Planning & Zoning Board Regular Meeting

August 1, 2023 @ 6:00 pm

4. **Public Hearings**
(Public participation and comment on these matters must be in-person.)
 - a. [SPR #23-09. Request of Max Eliscu.](#) 10 minutes
Request of Max Eliscu for approval to construct a new, single-story, 748 square-foot cabana and a new, two-story, 1,001 square-foot addition to the existing single-family home located at 802 Georgia Avenue on Lake Osceola, zoned R-1AAA.

- b. [Request of Metro Winter Park, LLC: To amend the Comprehensive Plan Future Land Use designation from Institutional to Medium Density Residential to be consistent with the R-3 zoning of the properties and for Conditional Use approval for a two-story, 58-unit multi-family project on the properties at 821 & 831 W. Swoope Ave. and 800, 810 & 830 W. Webster Ave.](#) 60 minutes

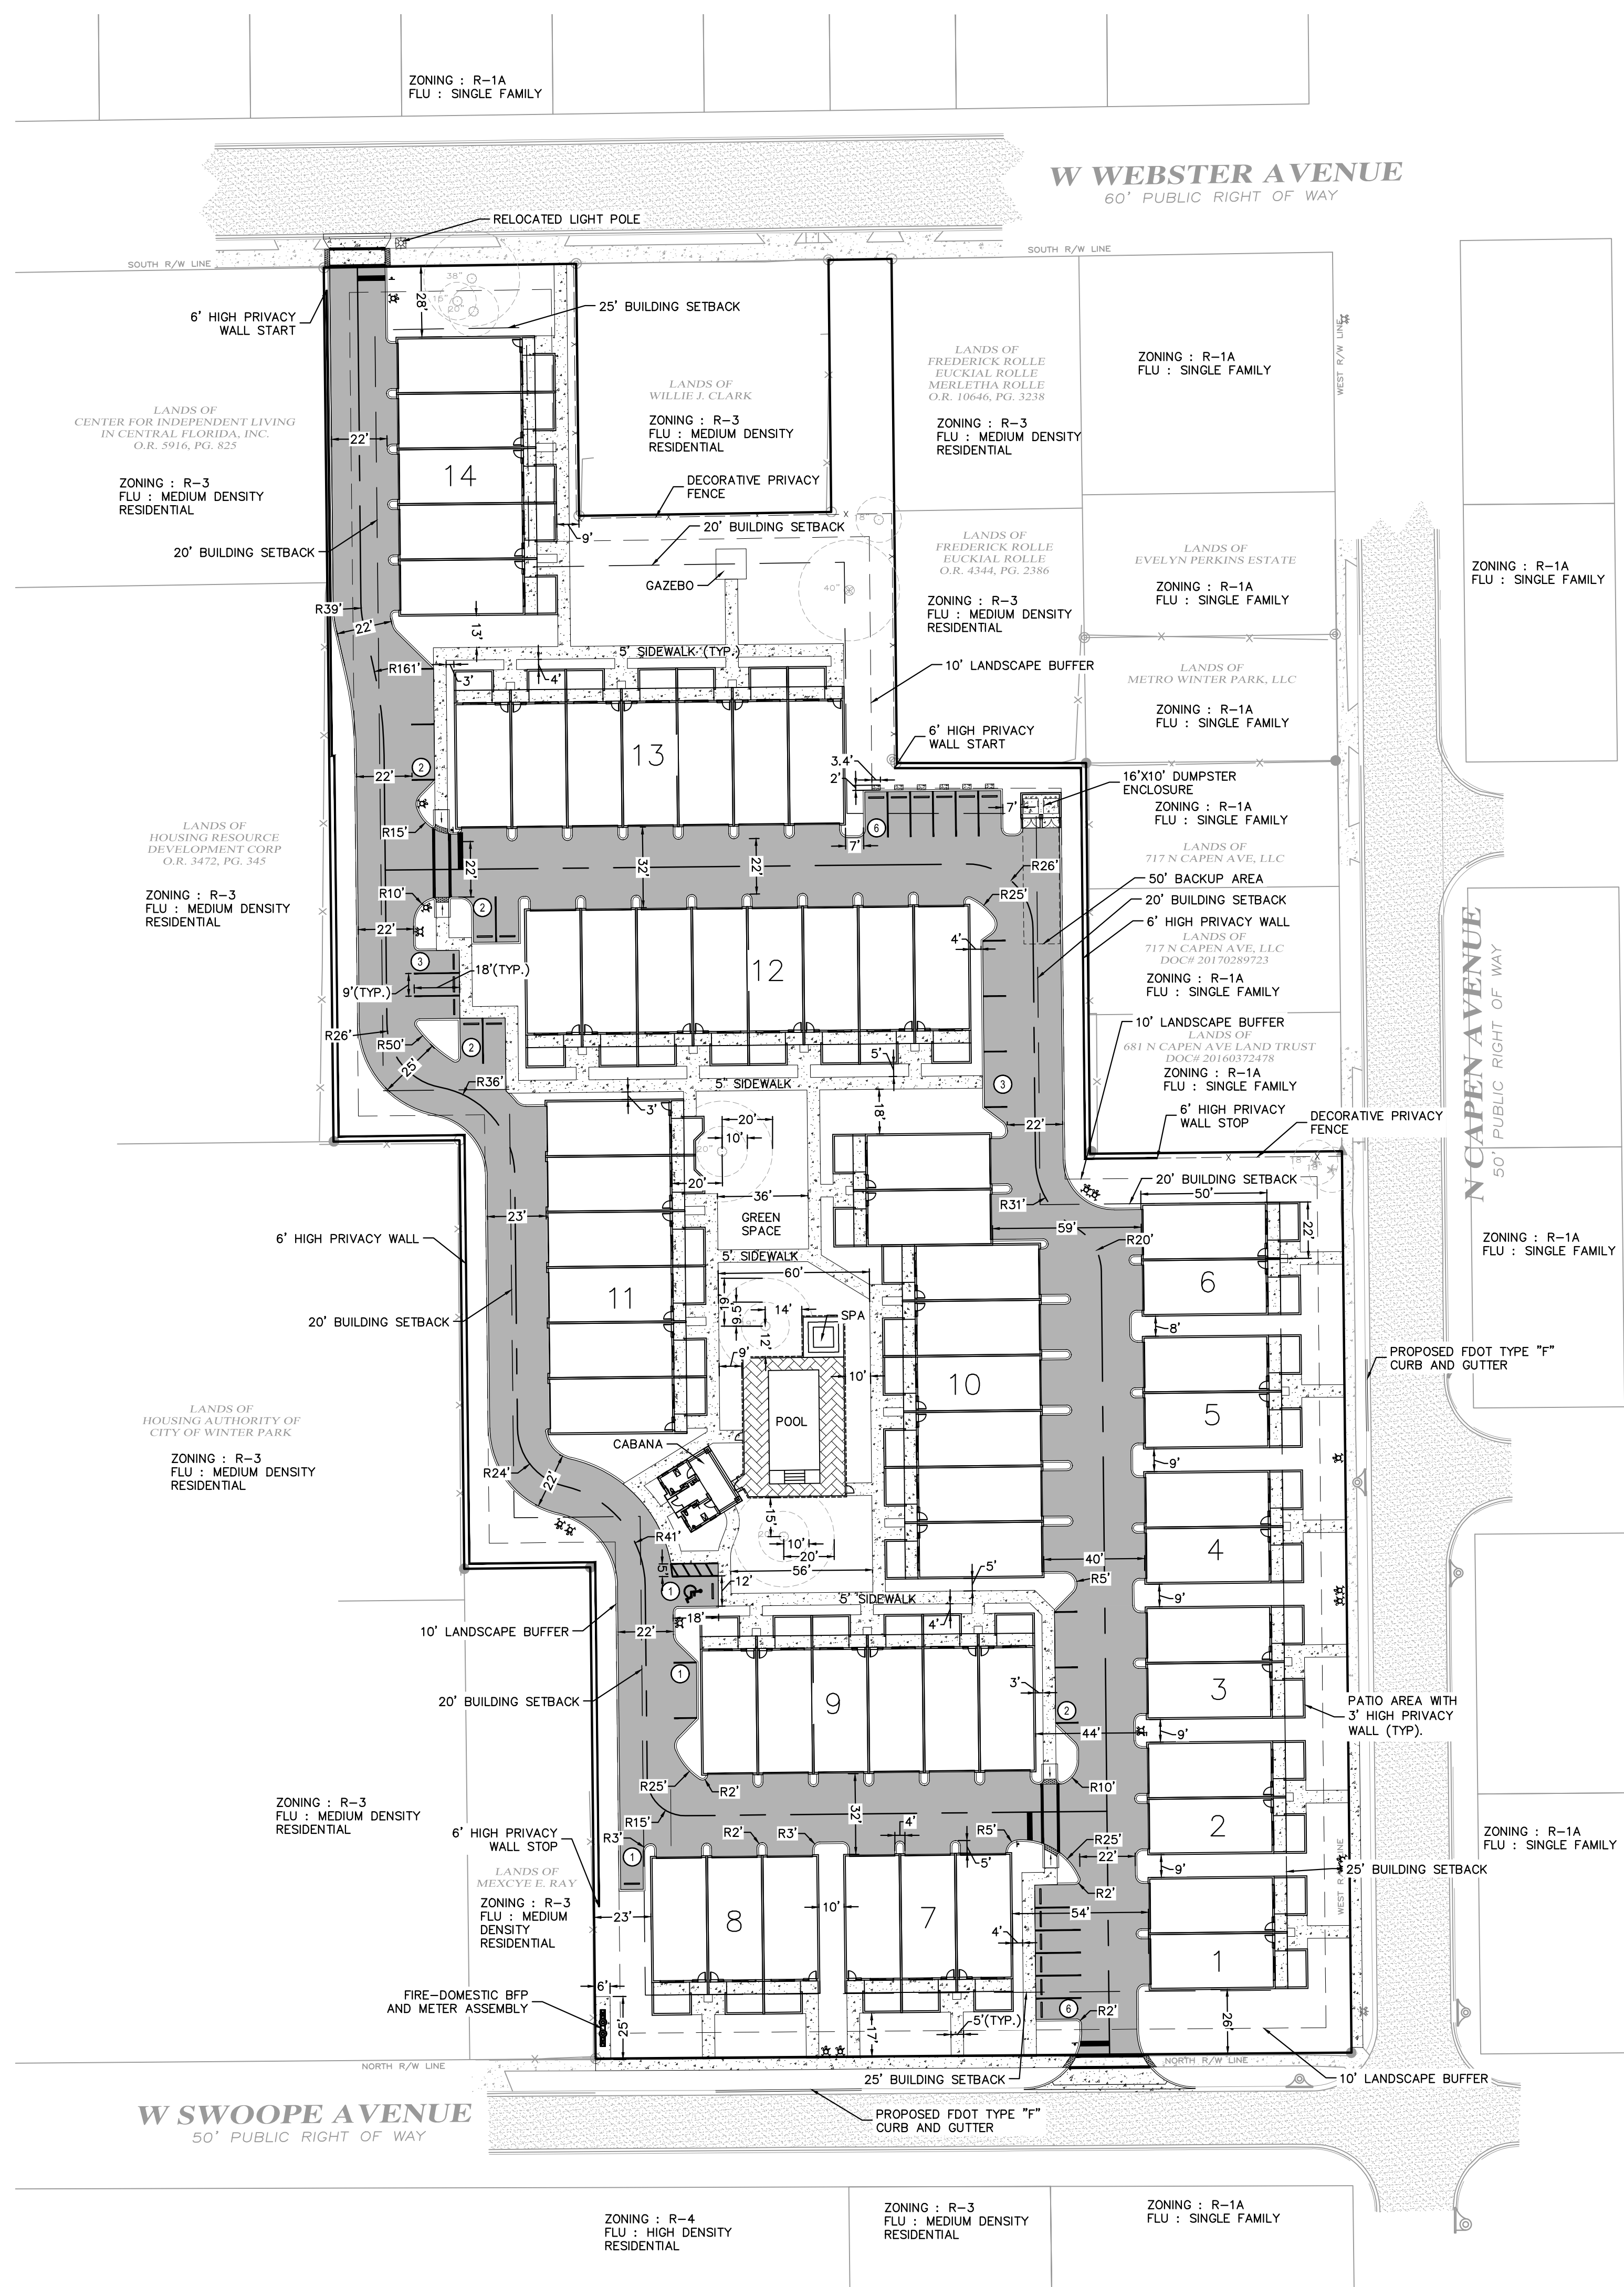
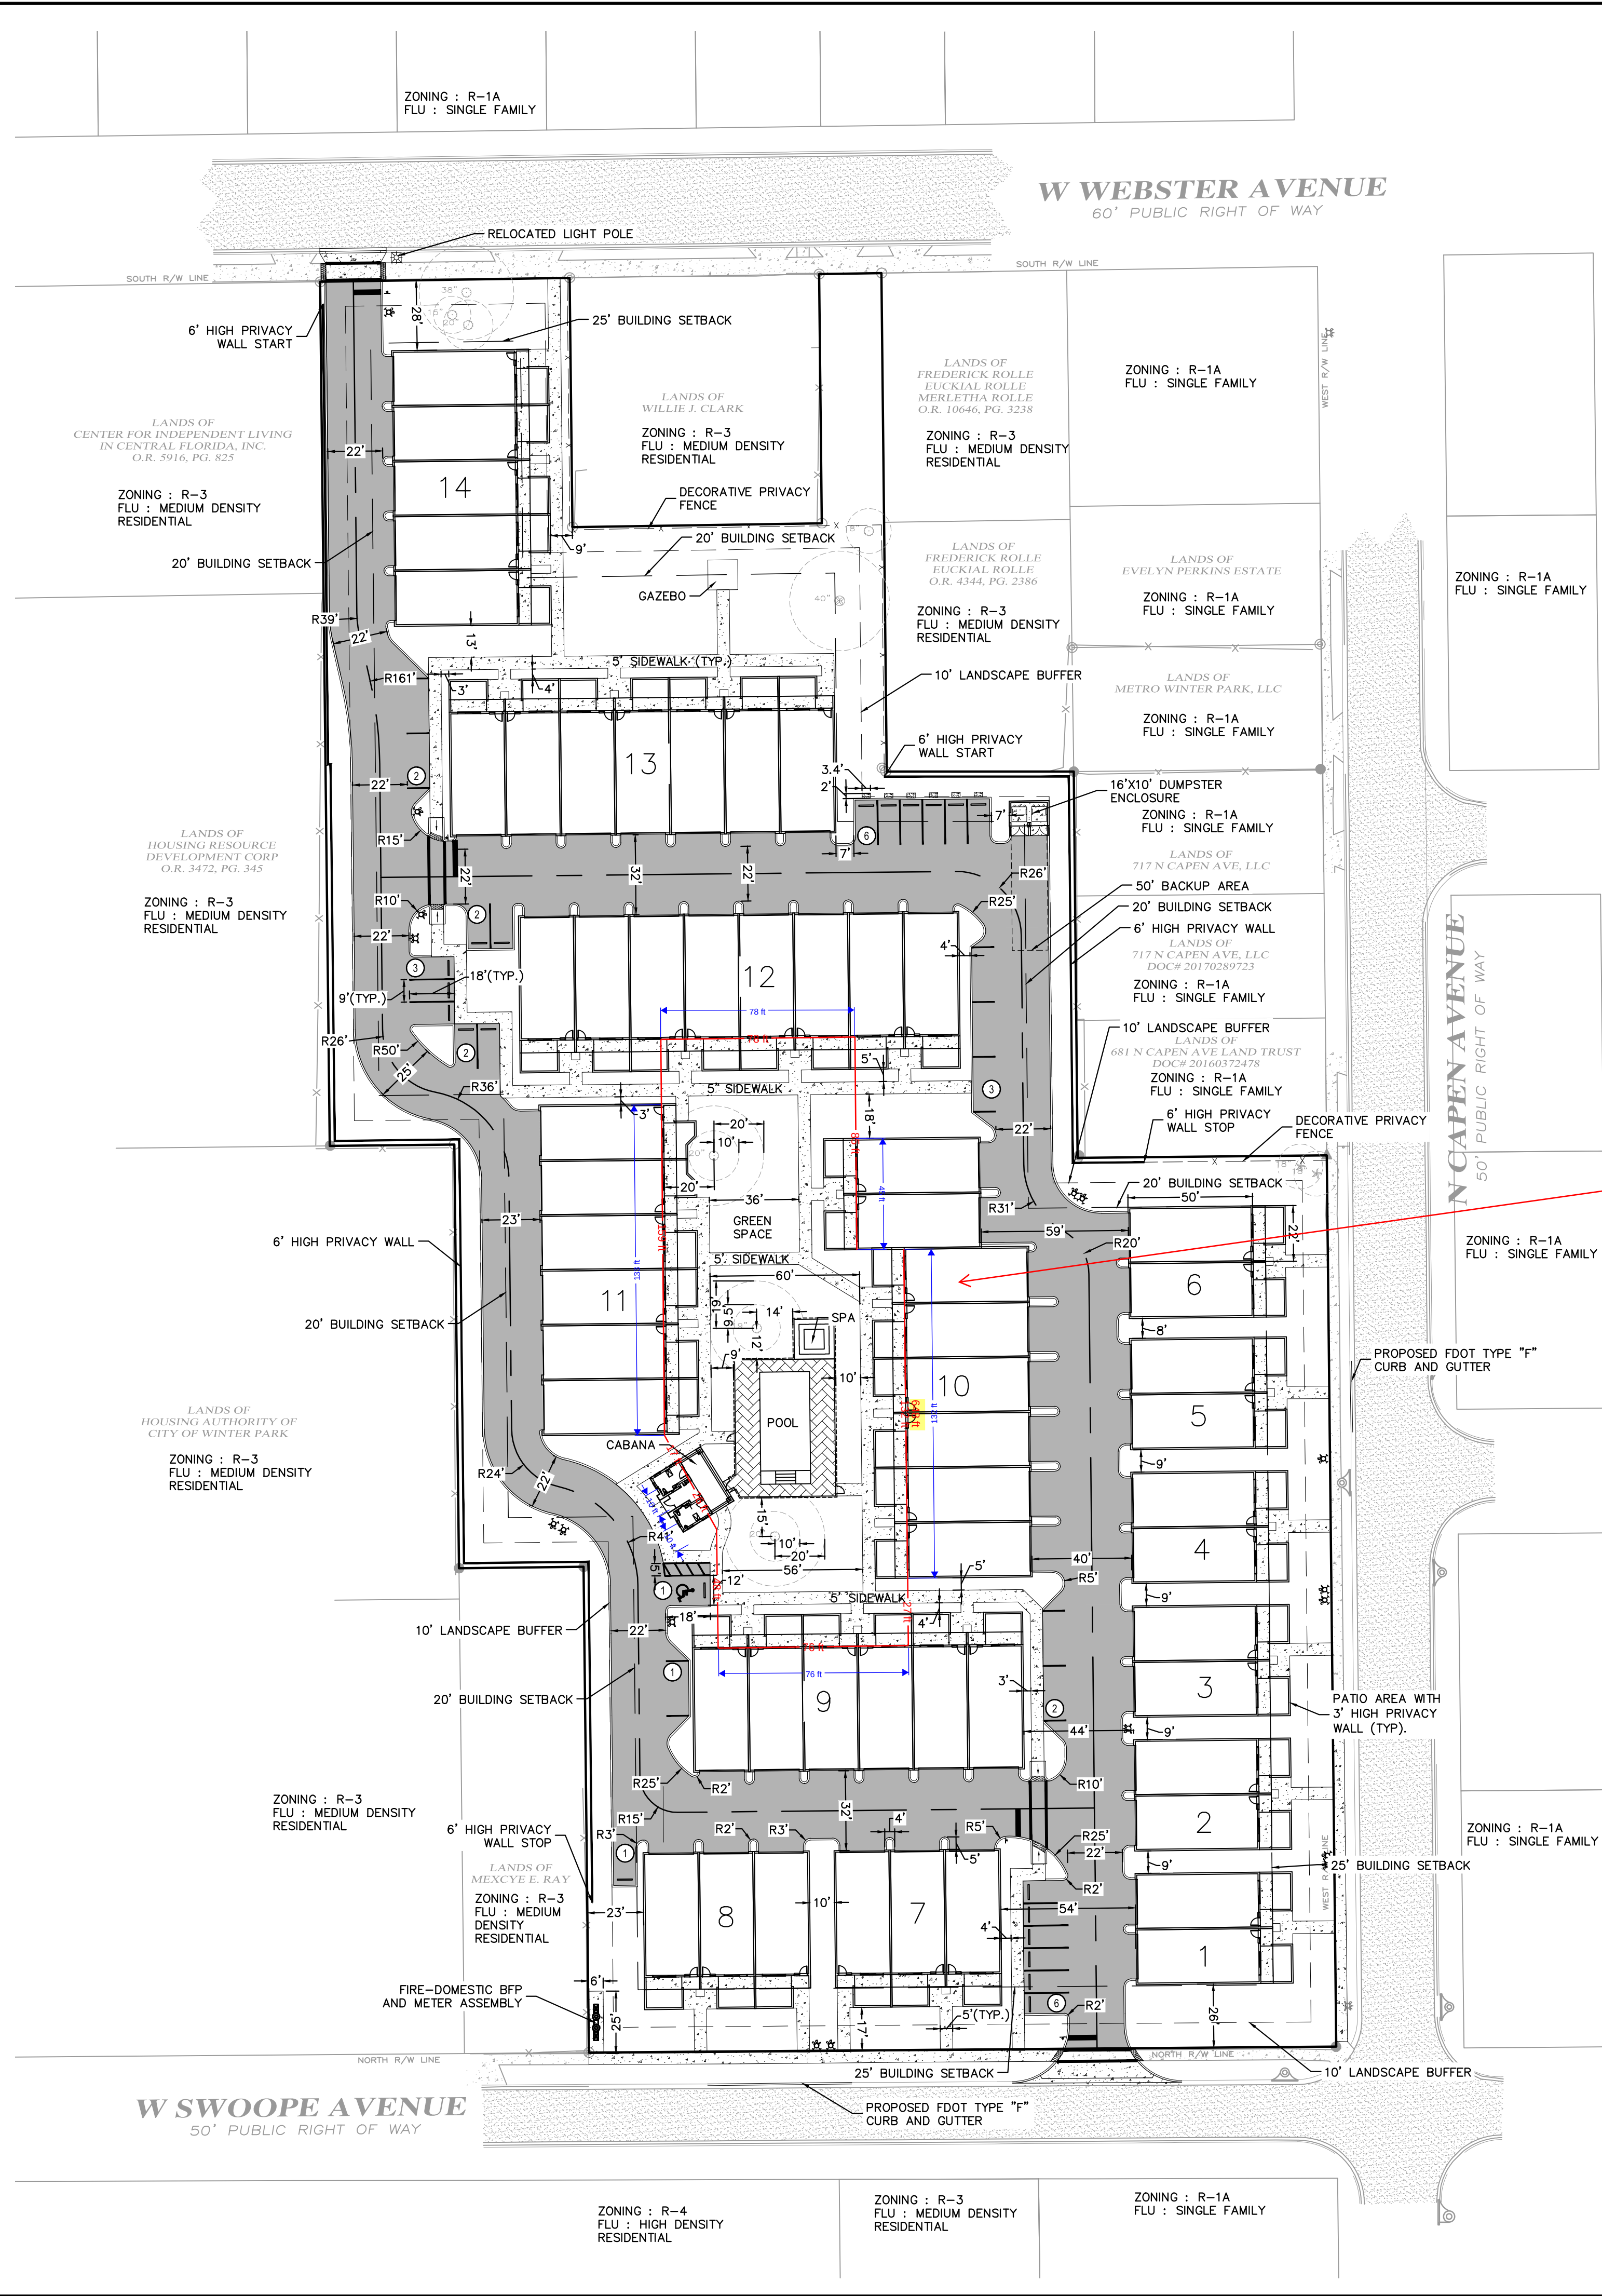
Conditional Use standard #5 states "that the building size, floor area ratio, height and mass are compatible with the zoning code requirements and "consistent with the scale and character of the immediate neighborhood" This proposed site plan and building configuration is not "consistent with the scale and character of the immediate neighborhood".

Conditional Use standard #6 states that “the topographical and natural features of the site shall be given priority consideration, thus assuring the retention of trees”. On this 4.51-acre site, there are just four mature healthy live oak trees that need to be given priority consideration and preserved. One tree sits on a northern property line in the setback area where it is not in jeopardy. However, the planning staff and urban forestry have issues with the way the applicant is attempting to preserve the other three trees.

The other three specimen live oak trees are clustered in the area proposed for the project amenity of the swimming pool and clubhouse. The City has requested is a 20-foot separation from any improvements to the trees in order to preserve the tree canopy and root system immediately adjacent to these trees. Twenty feet is comparable to the width of two parking spaces. The applicant is proposing to provide only 10 feet of separation which is comparable to the width of one parking space, from the trunk of these three healthy live oak trees. Once beyond that 10 feet, the applicant is proposing to trench for foundation footers, construct buildings, trench for retaining walls, build patio decks and the swimming pool/pool deck. The conflicts are obvious. Ten feet away from one live oak, the branches are touching the walls/windows of a townhome building. Ten feet away from two live oaks is the swimming pool deck and pool water with tree limbs extending out over the pool water and tree root systems that are guaranteed to be lifting up the pool deck and patio decks causing such recurring problems that the project owner will certainly want the live oak trees removed. But that is unlikely to happen, because these three live oak trees will not survive those construction impacts.

The staff recommendation is for DENIAL. The legal basis for the denial is the failure to meet the three standards for approval of a conditional use as outlined in Section 58-90 (j) of the Land Development Code. The staff is hopeful that the applicant will revise these plans as indicated so that a resubmittal can be recommended for approval.
